FOR DA PURPOSES ONLY
NOT FOR CONSTRUCTION

PROJECT:
1 LAWSON SQUARE, REDFERN
CLIENT:
LAWSON SQUARE PTY LTD.
SCALE:
1:200 @ A1
DATE:
SEPTEMBER 2017
DRAWN BY:
RYESJEMT
CHECKED 1:
RY
CHECKED 2:
JE
APPROVED:
=

DRAWING:
ELEVATIONS SHEET 1 NORTH ELEVATION
DRAWING No:
S96 - 1301

01 NORTH ELEVATION
1:200

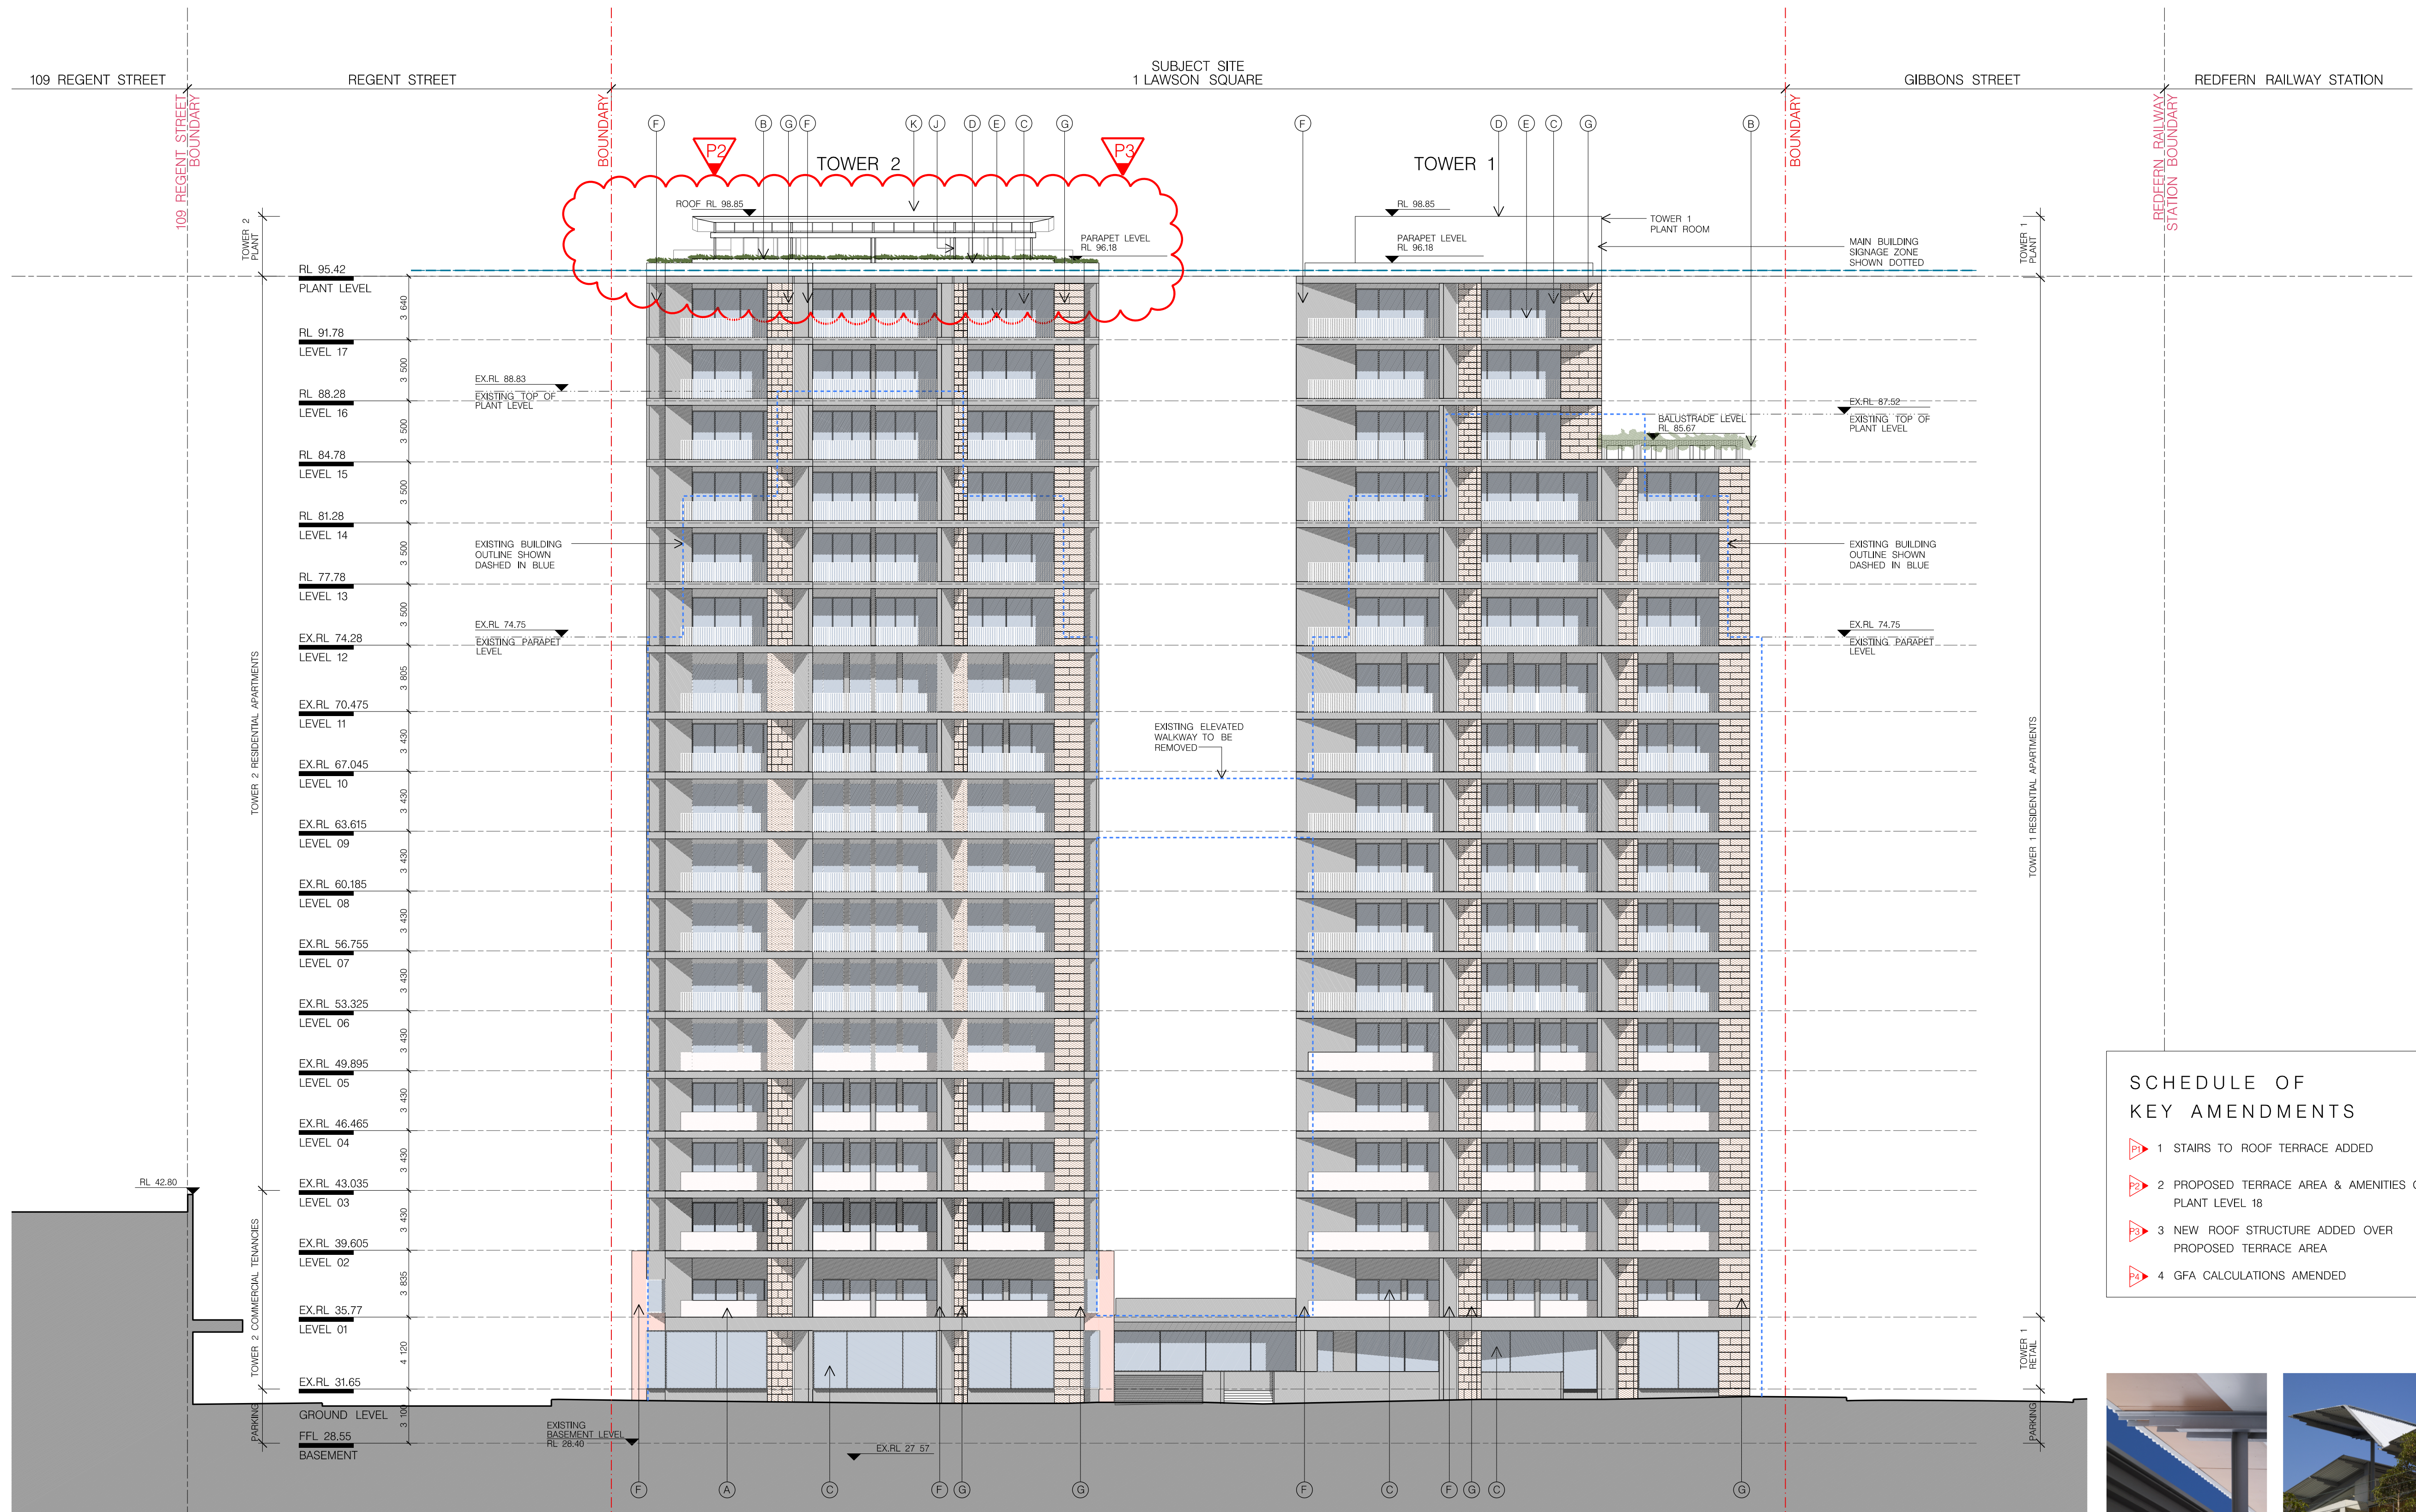
SCHEDULE OF KEY AMENDMENTS	
1	STAIRS TO ROOF TERRACE ADDED
2	PROPOSED TERRACE AREA & AMENITIES ON PLANT LEVEL 18
3	NEW ROOF STRUCTURE ADDED OVER PROPOSED TERRACE AREA
4	GFA CALCULATIONS AMENDED
